RFP No: 22-MABC01

**ADDENDUM No. 1**

**CONSTRUCTION MANAGEMENT, INSPECTIONS AND MATERIALS TESTING  
for the  
Monument Academy Recirculation Project**

**DATE OF ADDENDUM: May 9, 2022**

<b>MONUMENT ACADEMY ROADWAY PLAN AND PROFILE BACK OF SCHOOL ACCESS ROAD</b>			
Designer:	J. WILKERT	Structure Numbers	
Detailer:	J. WILKERT		
Sheet Subset:	ROADWAY	Subset Sheets:	2 of 6

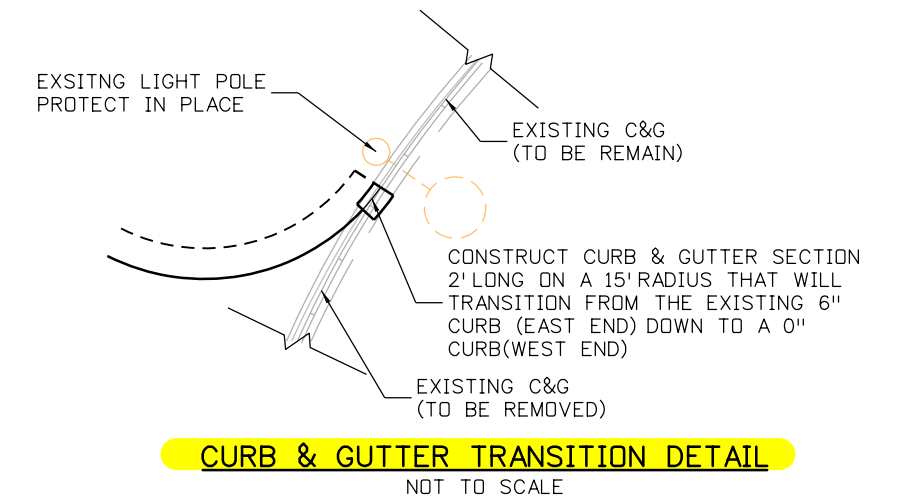
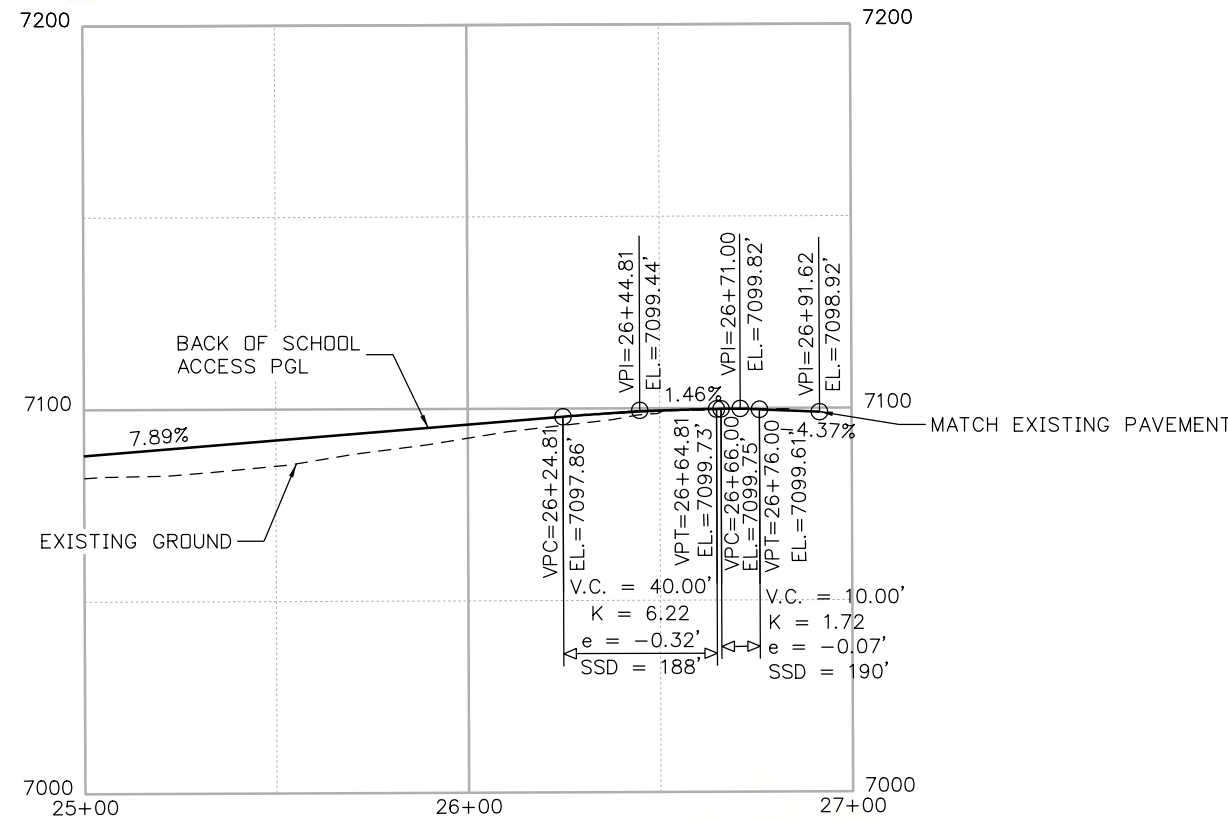
1. Onsite topsoil may be salvaged during clearing and grubbing, stockpiled and utilized in lieu of, or in addition to, offsite topsoil. All labor, equipment and materials associated with topsoil will be paid at the bid unit price of Topsoil (Offsite).
2. See attached for the detail for the bull nose curb.
3. See attached Minimum Materials Testing Requirements
